TECHNICAL BULLETIN

[Issue No.] T08-0009

[Title] Precautions for Starting Up CC-Link System Power

[Relevant Models] AJ61BT11, A1SJ61BT11, AJ61QBT11, A1SJ61QBT11

(Example of sequence program to restart link after all stations have started (correct communication with all stations))

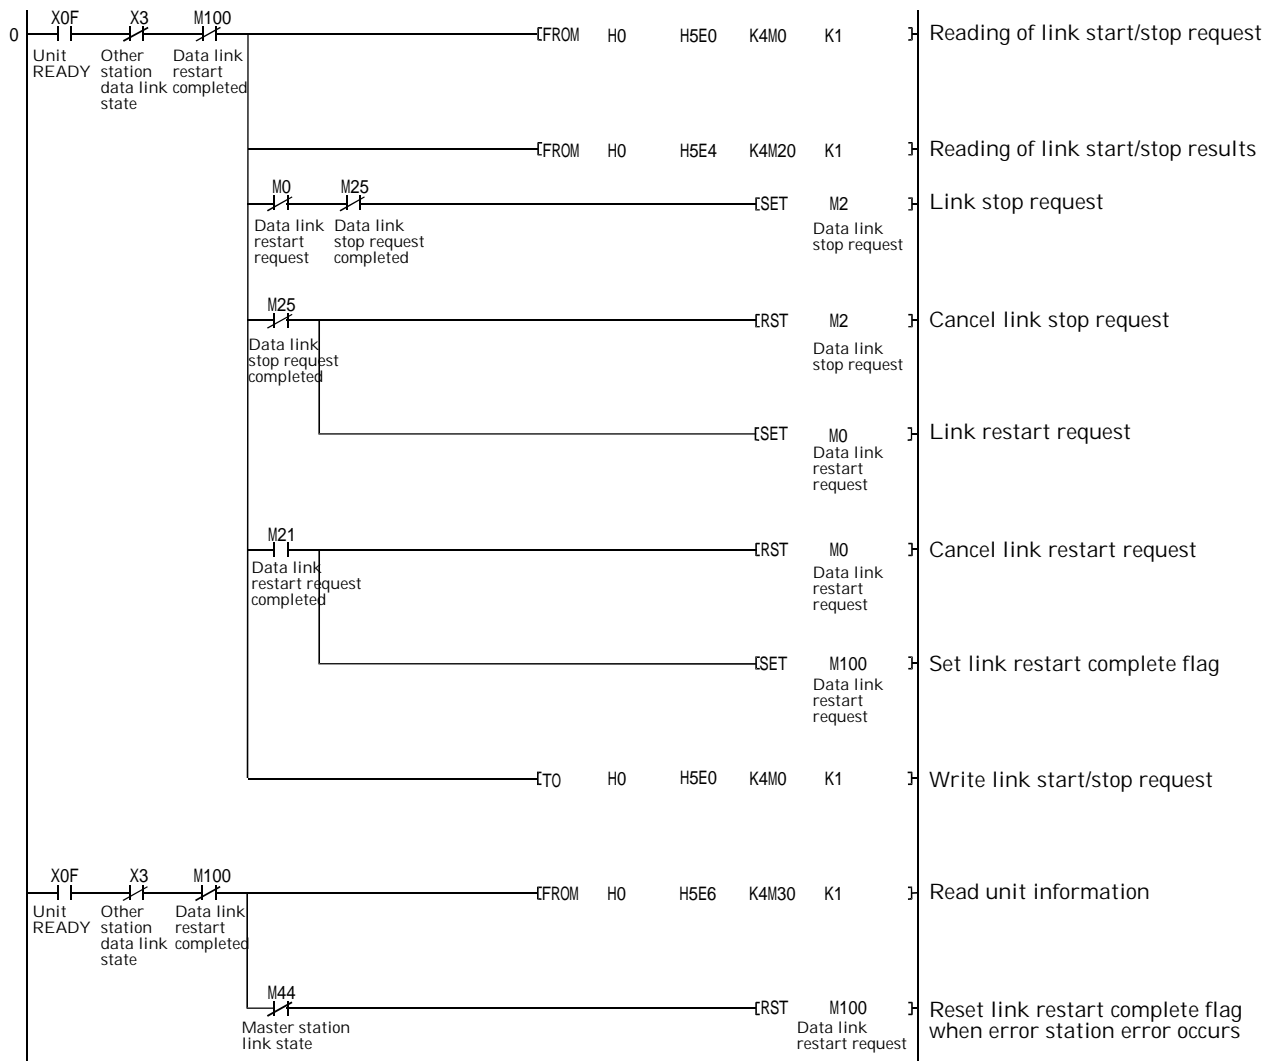
- * The above phenomenon will not occur if after the data link system is started (correct communication is carried out with all stations), the remote station power is individually (other than all stations) turned ON or OFF.
- * When the master station power cannot be turned ON last due to the CC-Link system, execute a sequence program at the following timing to restart the link after all stations have started (correct communication is carried out with all stations).
An example of the circuit is shown on the next page.

Immediately after executing "link parameter setting" in the master station, execute the sequence program to restart the link.

- * The I/O address Nos. indicate the numbers for when the master unit is mounted in Slot 0 of the basic base unit.
- * The M device No. must be a device not used in the program.
